PAVEMENT DESIGN REPORT

**Skyline at Lorson Ranch, Filing No. 1
El Paso County, Colorado**

**September 8, 2022
Revised September 27, 2022**

**APPROVED
Engineering Review**

**PAVEMENT
RECOMMENDATIONS**

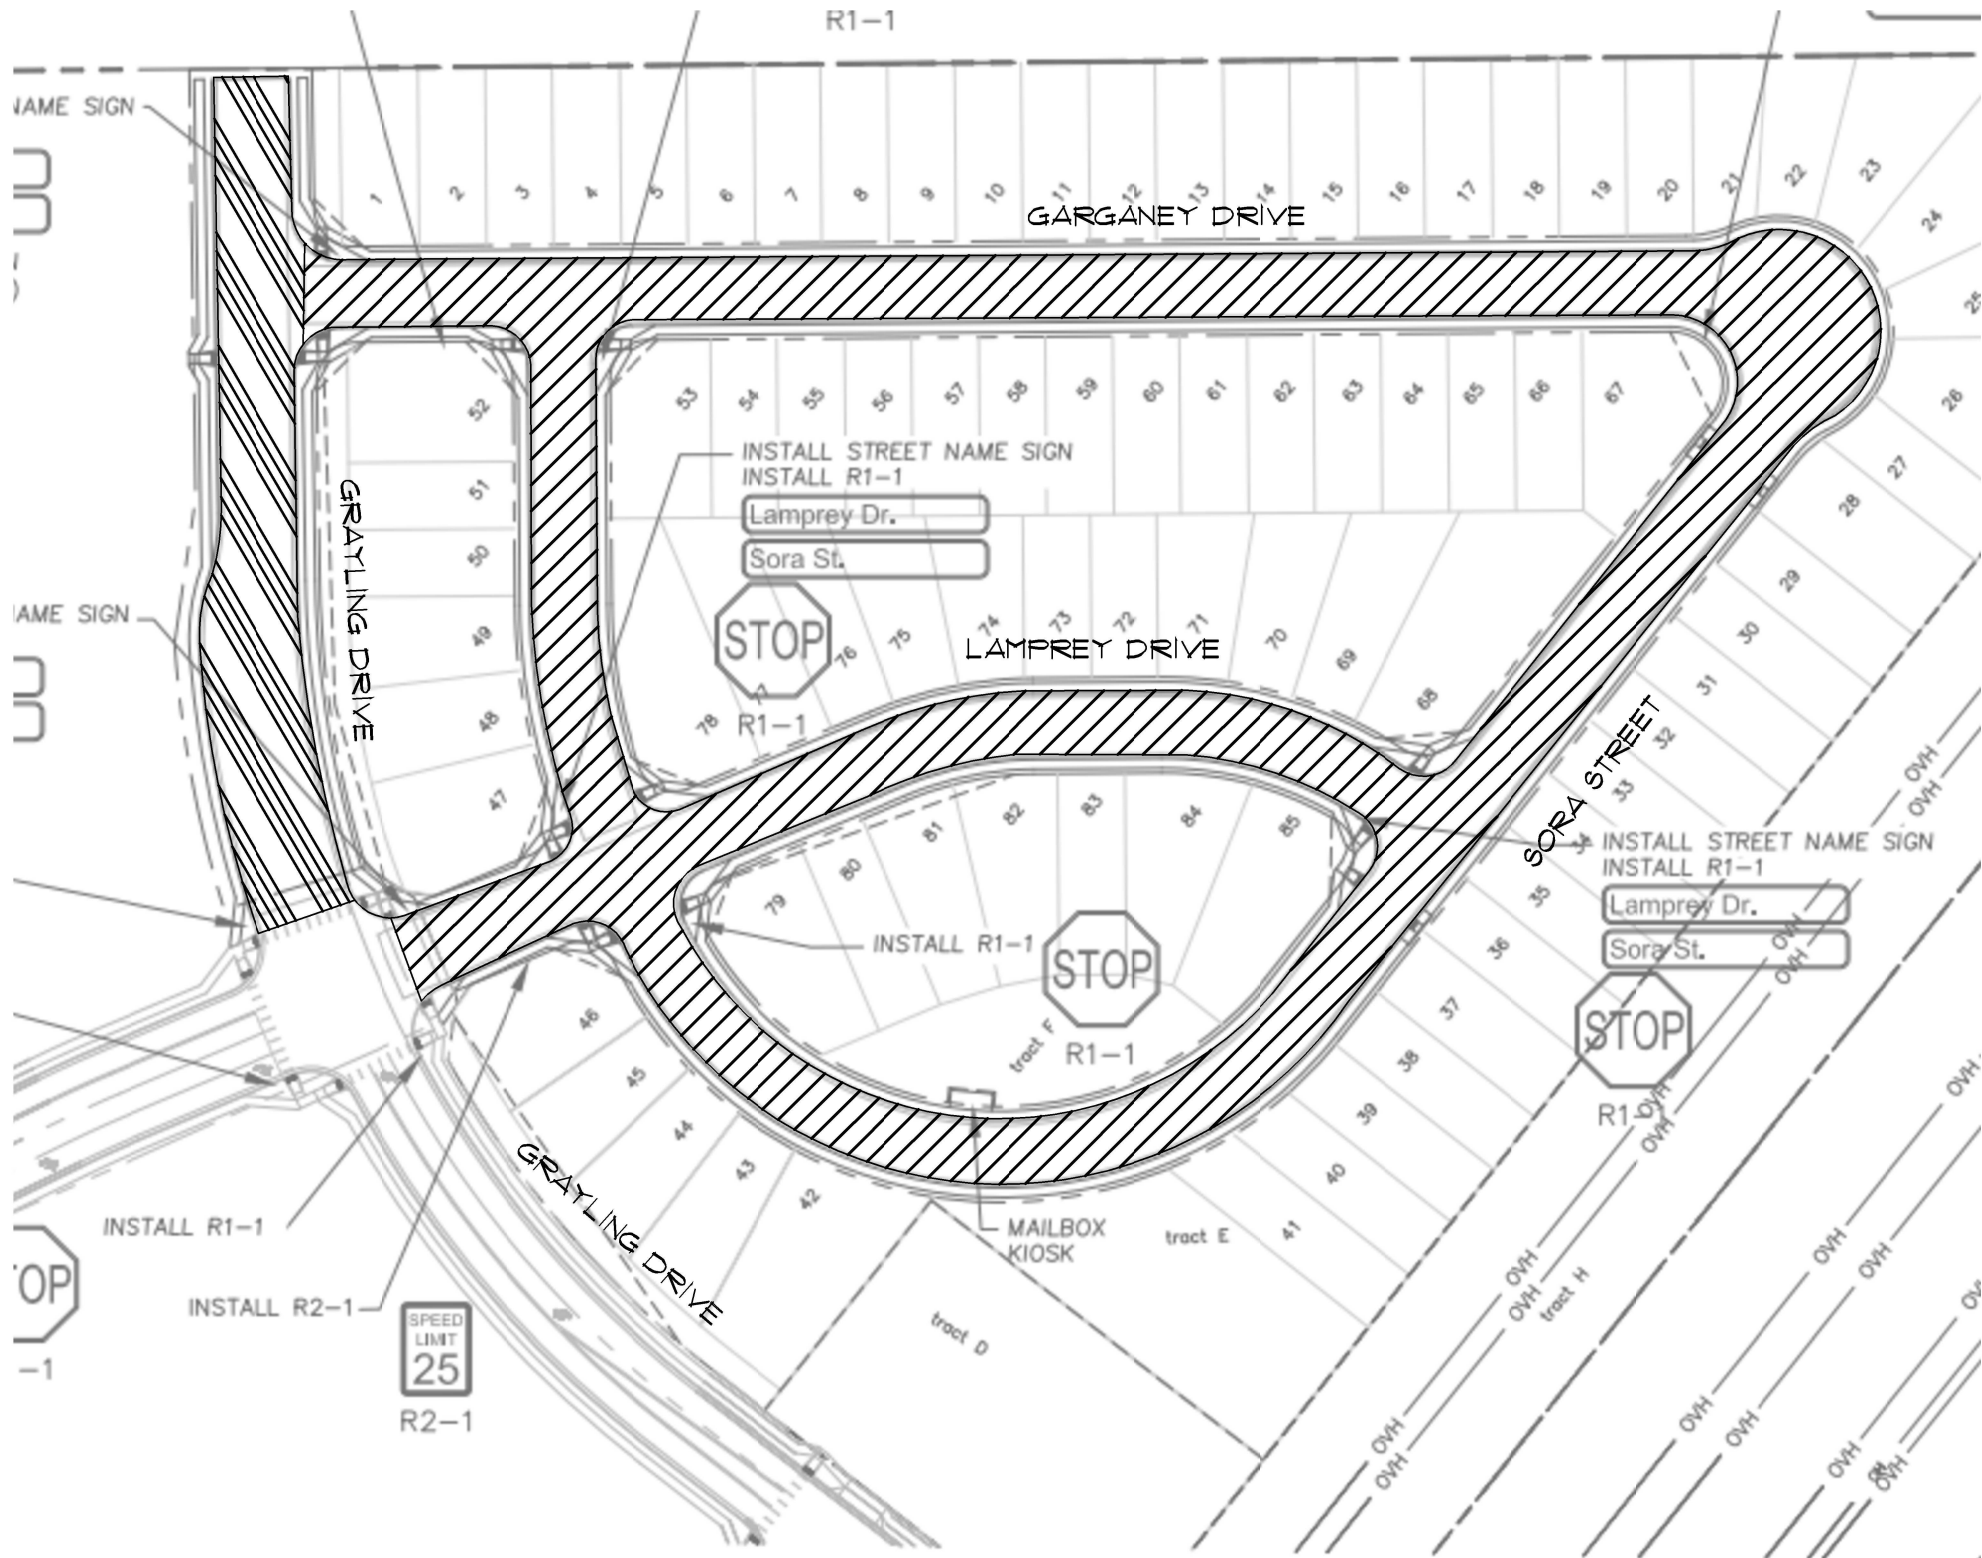
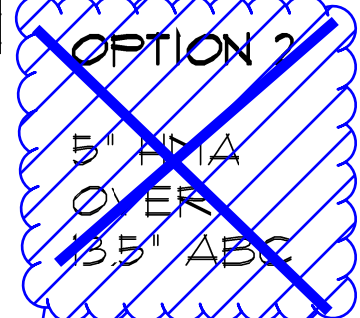
EPC Planning & Community
Development Department
Condition: For the Local
Residential roads, only
Option 1 may be used.

Basecourse
thickness exceeds
HMA thickness by
more than 2.5 times.
